Date: August 11, 2022  
To: Cumberland Planning Board  
From: Carla Nixon, Town Planner  
Subject: **Lakeside Concrete Amendment**

Date August 11, 2022  
To Town of Cumberland Planning Board  
From Carla Nixon, Town Planner  
Subject **Planning Board Site Plan Amendment Review – Lakeside Concrete Office Building and Contractors Space**

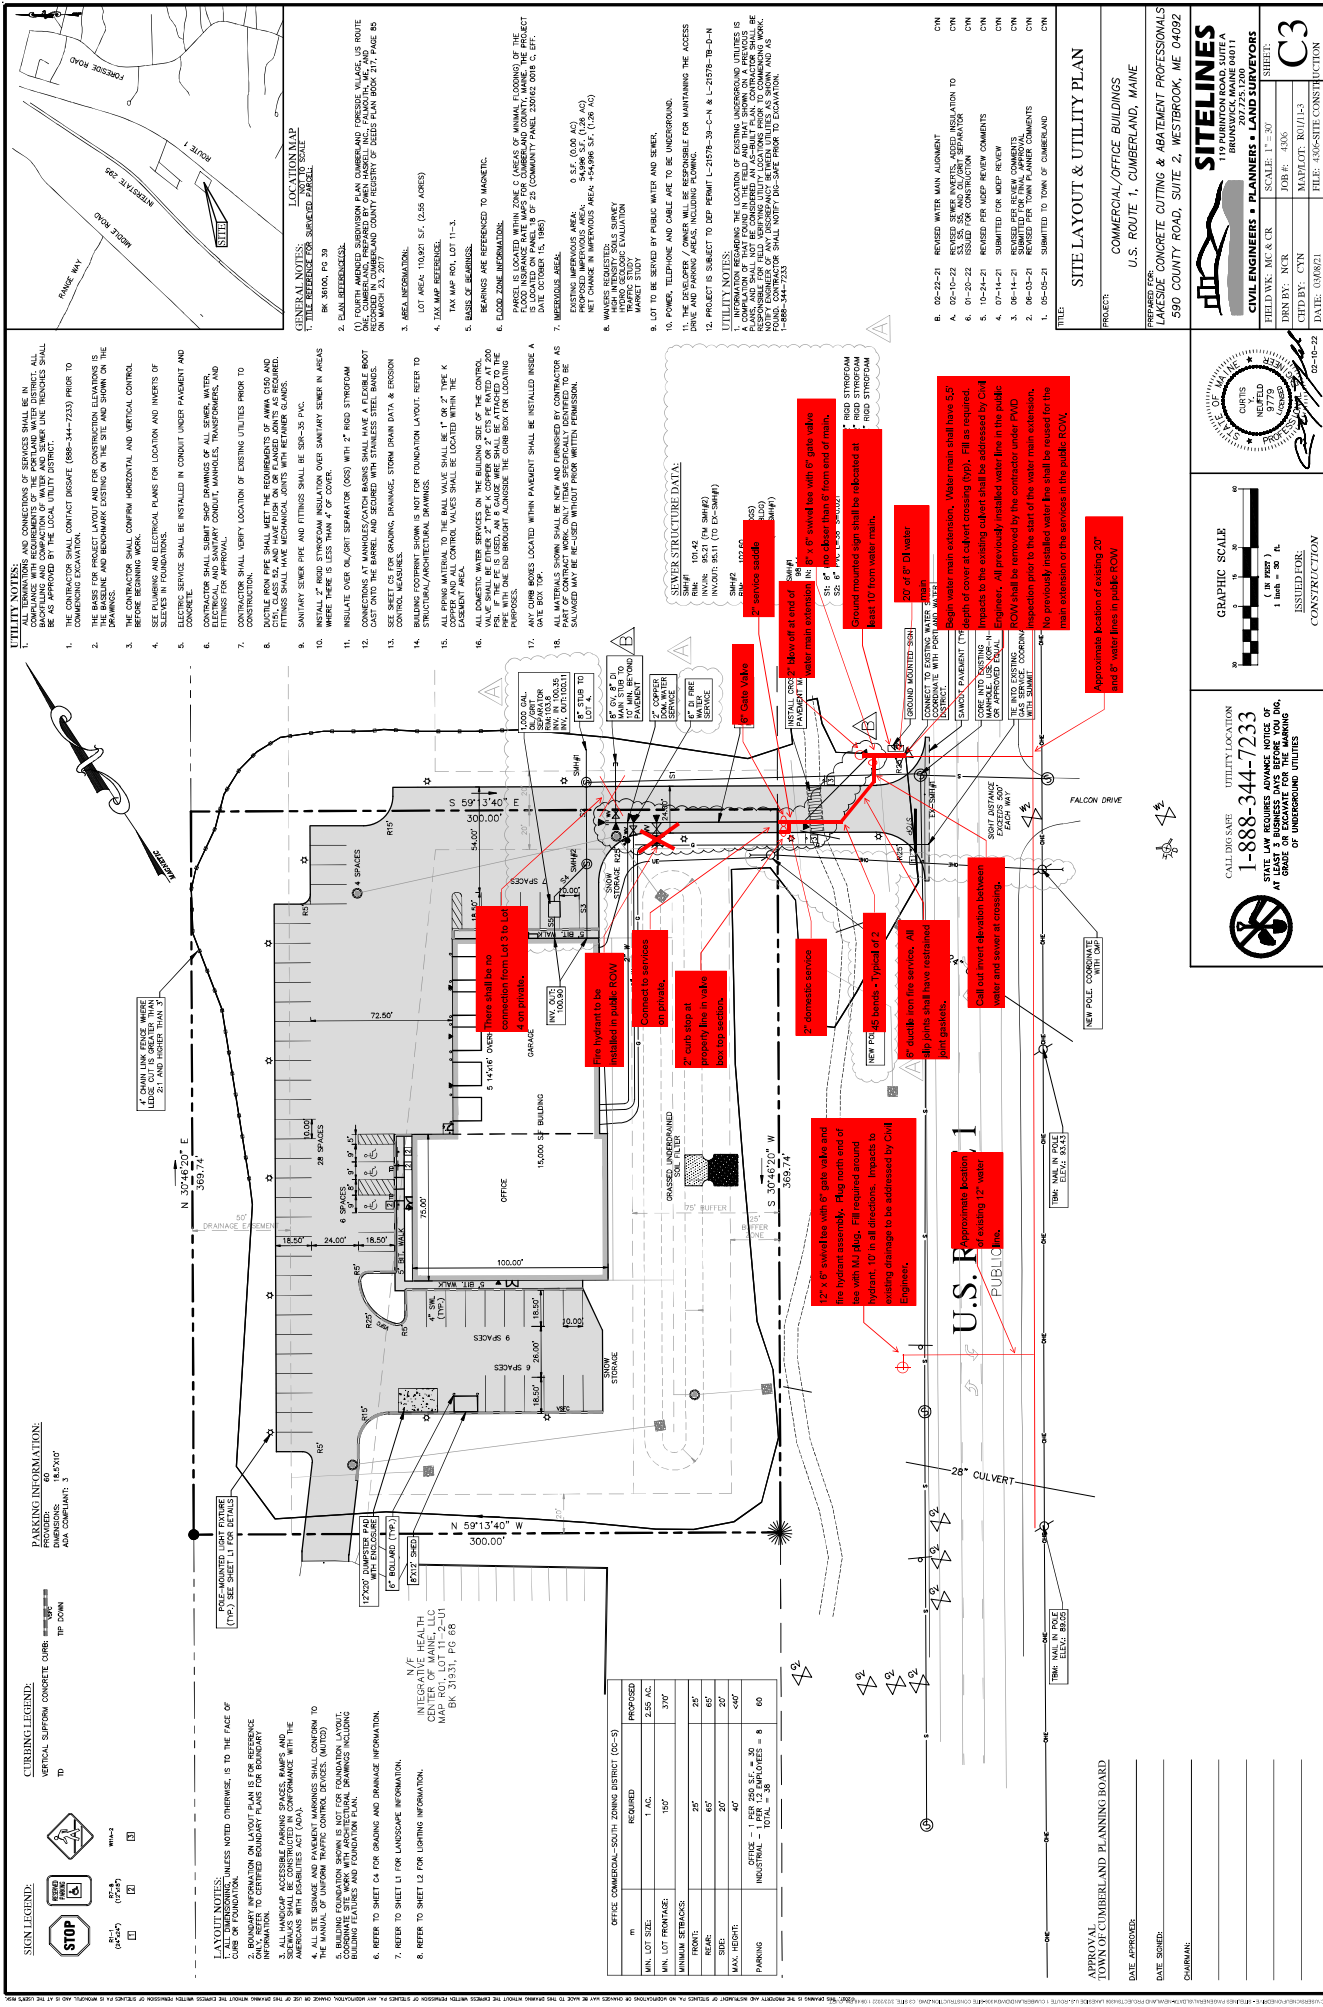
A public fire hydrant will be required on the existing 12-inch water line that crosses US Route 1 on the frontage of Lot 3.

PWD is providing markups to the development team as part of this appeal response that reflect the changes as described above.

SHEET:  
**C5**

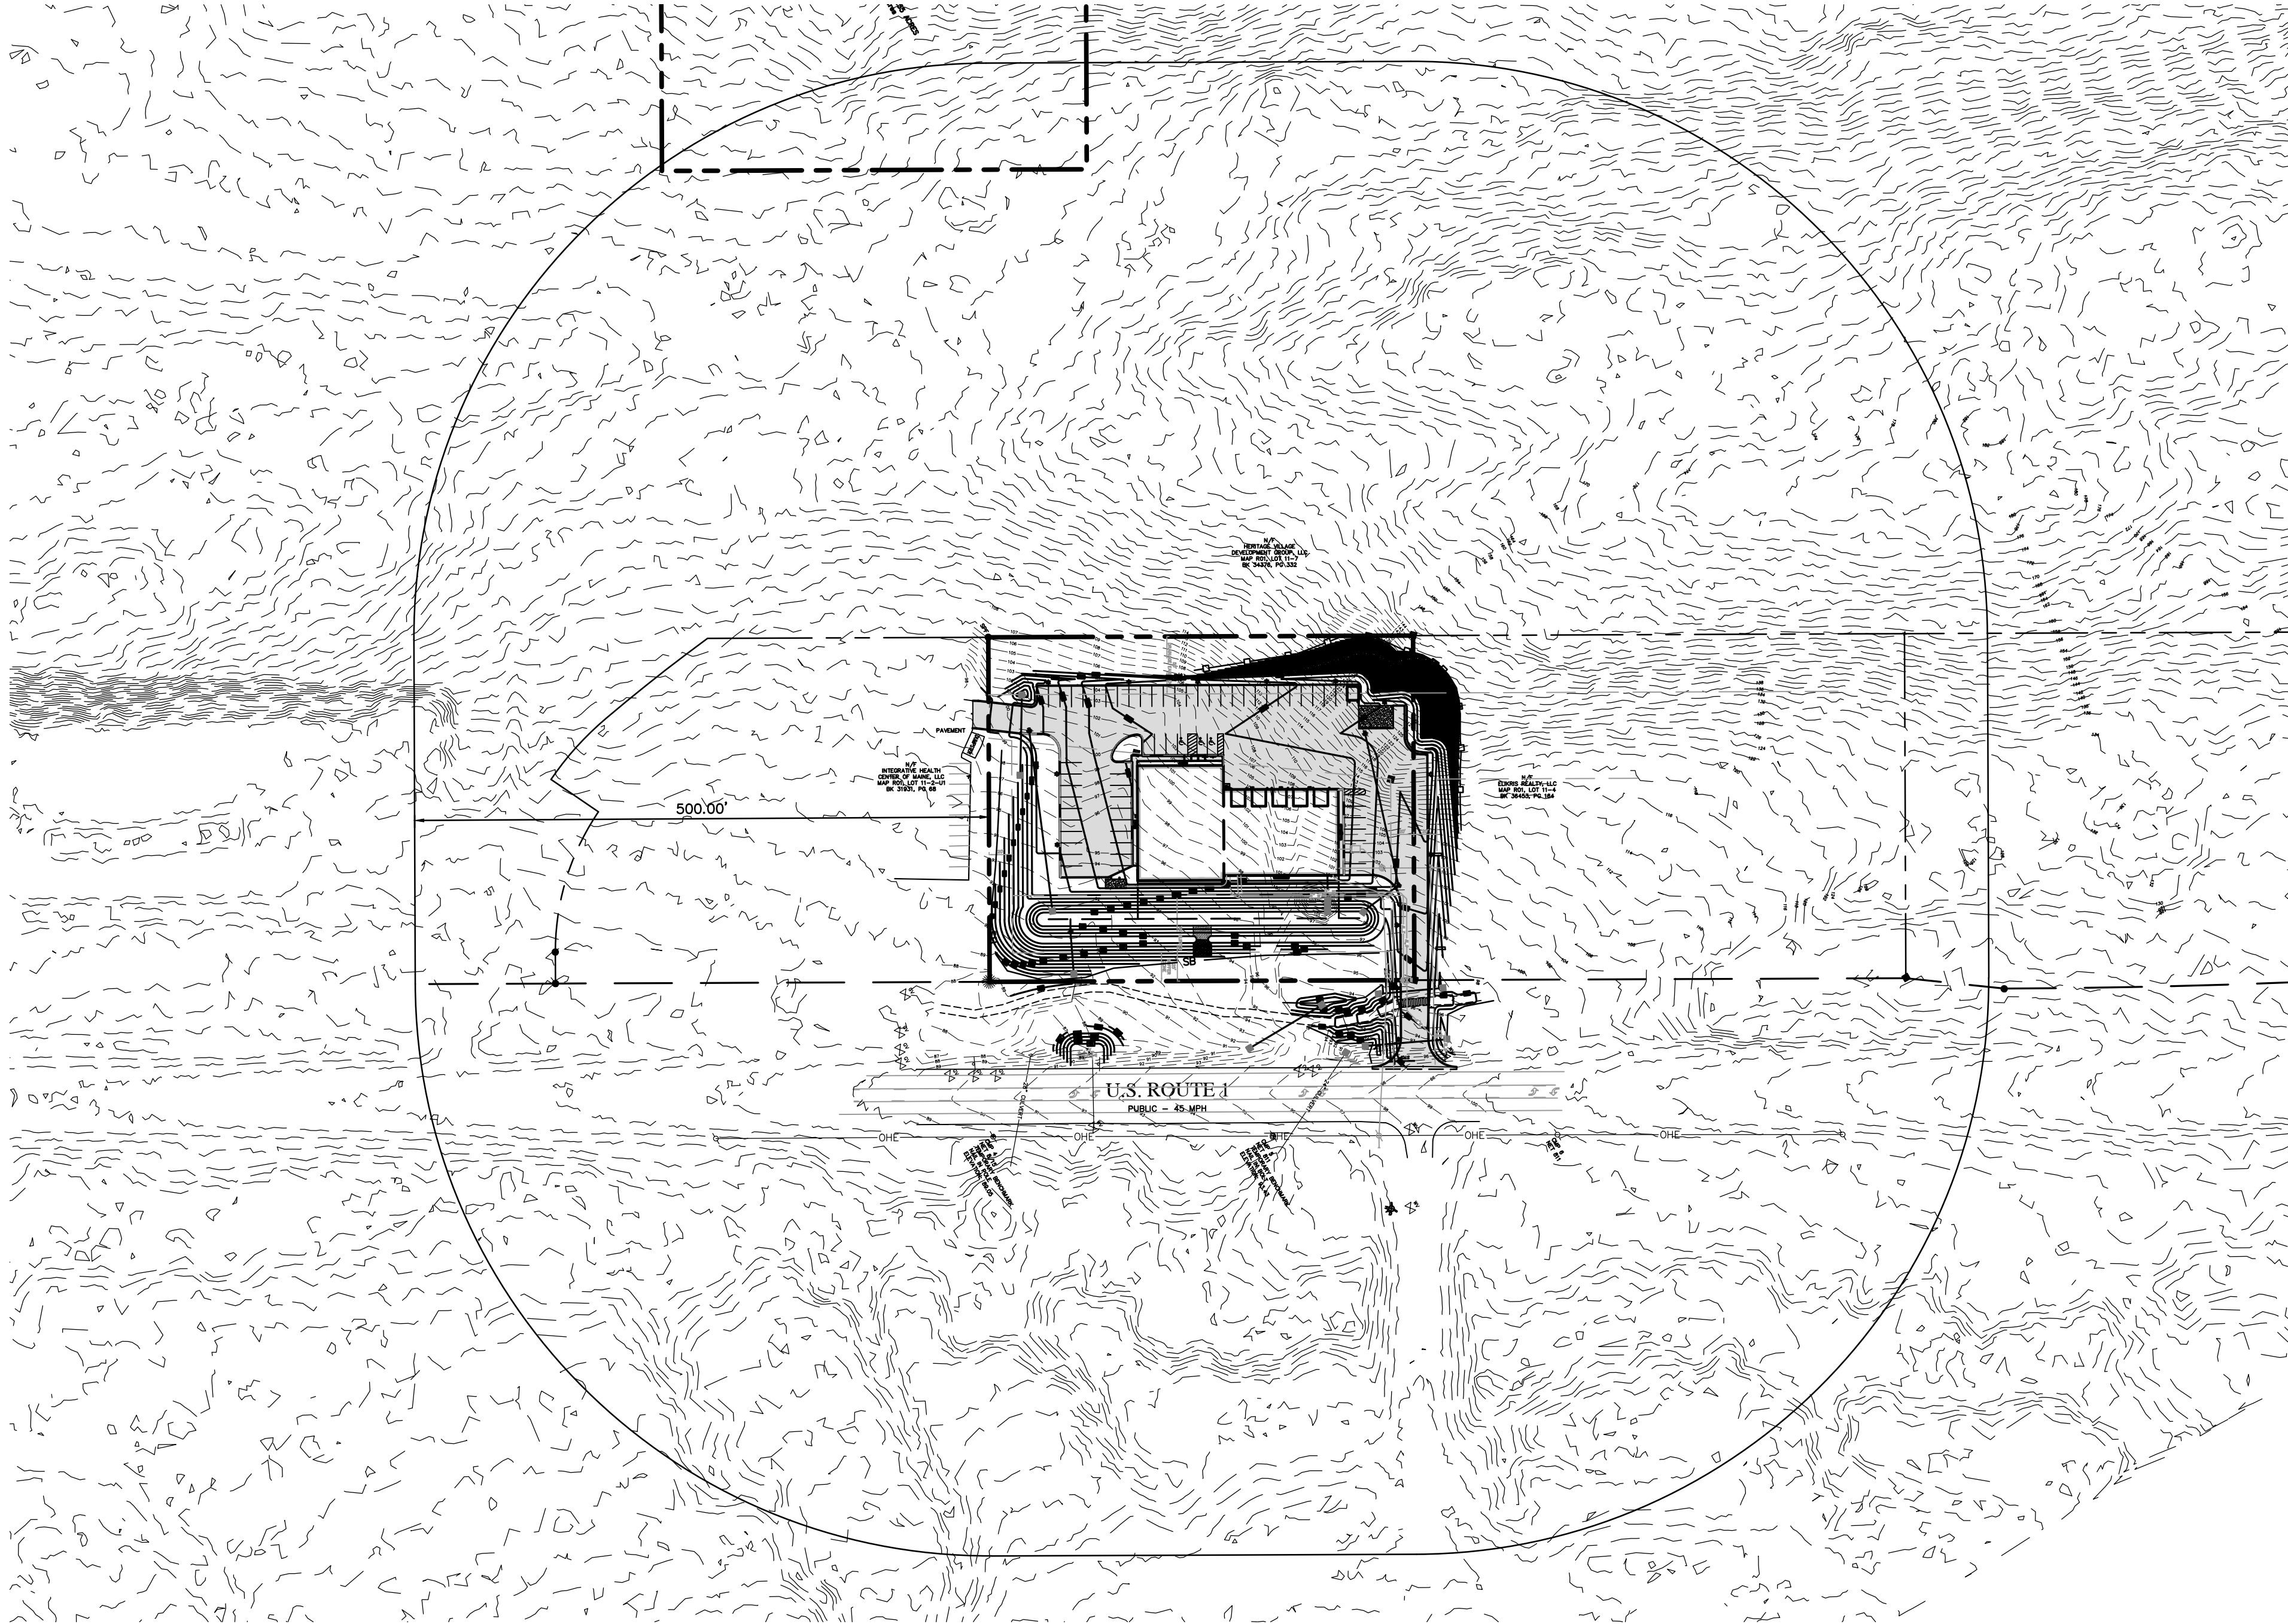
6. The Site Section on Plan C5 indicates plantings along the building of 10' to 15' in height. Please confirm that the Rhododendron proposed on the Landscape Plan will reach the heights shown.

A DUMPSTER DETAILS  
N.T.S.

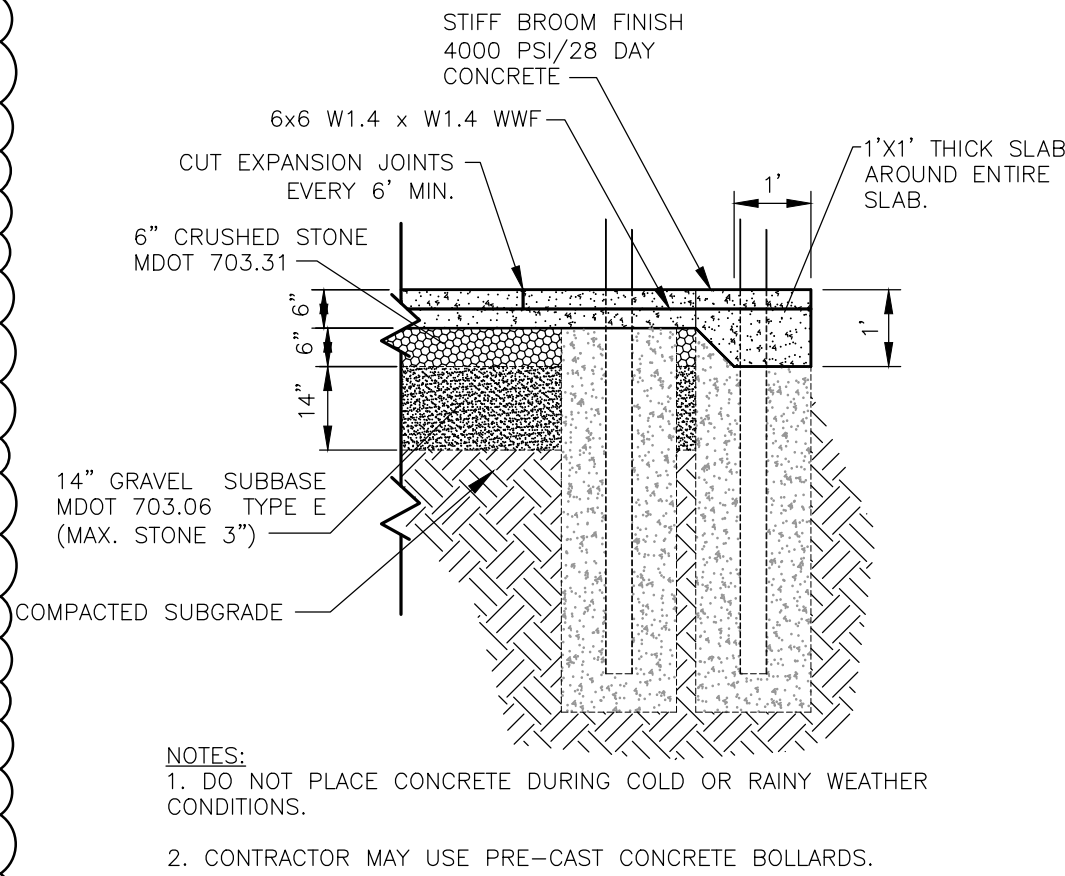
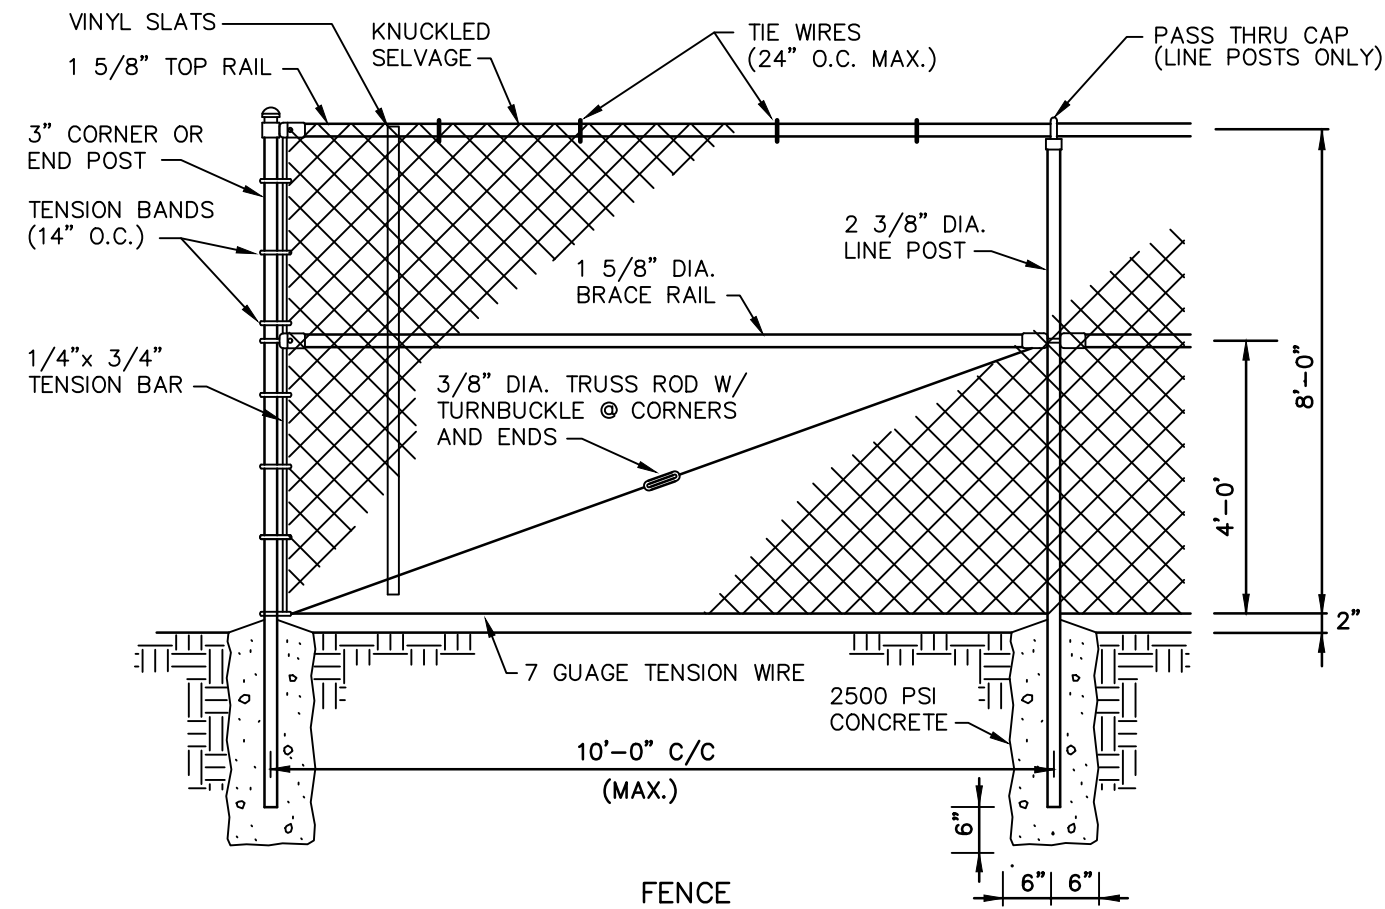
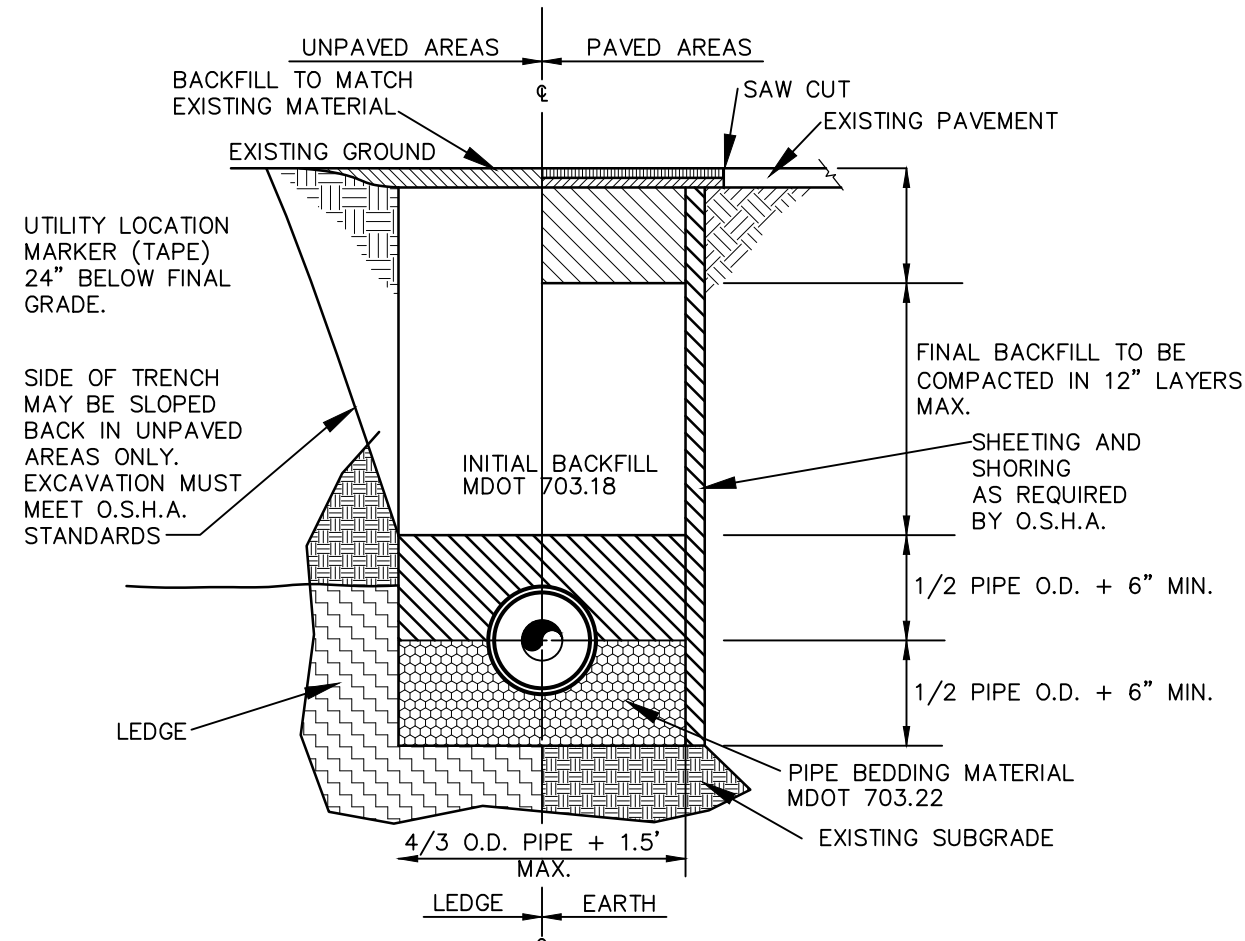
3. There is no detail drawing for the dumpster, the shed, or their enclosures.
4. No elevation drawings for the building have been provided. This is needed to show conformance with the Route 1 Design Standards.

3. The fence on the dumpster pad detail does not appear to provide any screening of views along the site entrance or to the abutting property to the north.. SME recommends that additional screening (privacy fence, wooden stockade fence, etc.) be added to fully encompass the Dumpster Pad based on this relocation.

4. Please provide gate details for the dumpster fence enclosure.
5. It appears that the southernmost pavement extents have been shifted north by approximately 20-feet. Please consider regrading the area outside of the pavement extents to reduce the overall site footprint.

**The details for the dumpster pad and enclosure are shown on Sheet C10. The dimensions for the dumpster pad shown on the detail have been revised to match the site plan. The dumpster pad will have an 8-foot chain link fence with vinyl slats screening the front of the dumpster pad facing towards Route 1. The remainder of the dumpster pad will be unscreened to provide better access to the dumpster for disposal and for emptying of the dumpster pad. The dumpster pad is naturally screened on the northwest and northeast sides by the ledge cut and, with the new location, is more than 300-feet from the abutter to the southwest.**
